## Tech Note

From Residential and Commercial Comfort Controls  
Date: 2004.06.01

## Spindle extension for FHV-R valves

Fig. 2: Instruction in mounting the spindle extension

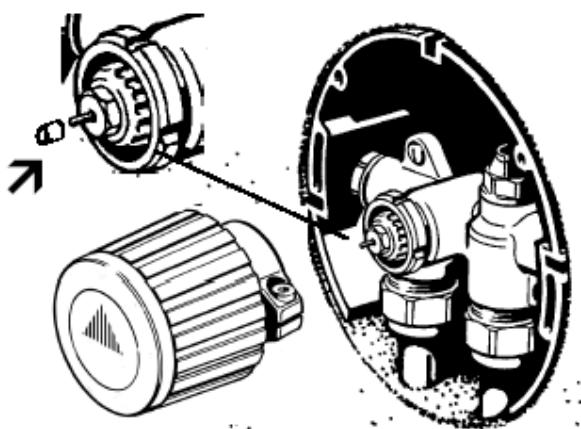
This spindle extension can correct an error in the closing measurement on some installed FHV-R valves. The error may be experienced with valves produced until March 2004. The customers will experience the error as a difficulty with adjusting their heating (the valve closes at too high a temperature).

The spindle extension is meant for FHV-R valves with order numbers 003L1000, 003L1003, 003L1006 and 003L1016.

003L1017 (10 Pcs spindle extensions)
